From: Amanda Evans [REDACTED]
Sent: 29 December 2022 15:55
To: Planning Planning; Sam FitzPatrick
Subject: Planning Application 2022/4190/P - Objection
Attachments: Planning application 2022.pdf

Planning application 2022/4190/P

I strongly object to the proposals to place telecoms equipment on the roof of Crestview.

Photo below - Proposed equipment on Crestview roof:

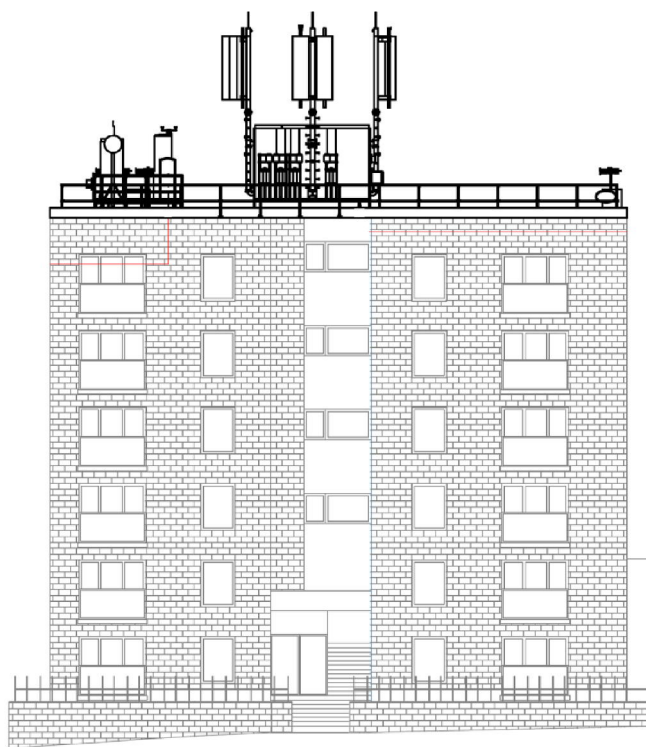
The proposed installation of telecoms apparatus is quite disproportionate in size to the block itself - the height from our main roof to the top of the antennas is between one third and one half the total height of our dwellings below.

- clustering 6 antennae (substantially bolted to our simple lift-housing unit),
- placing 7 large telecom units (some of a similar height to the lift-housing) on the flat roof,
- erecting a dish supported on a free-standing metal frame positioned over a resident's balcony at the front of the building,
- plus additional railings, trays and cables ... are all insensitive and incompatible to the residential environment.

The visual clutter remains. It would also compromise and disfigure the simplicity of the host building.

The thin asphalt roof of the building is not designed to support any weight or traffic.
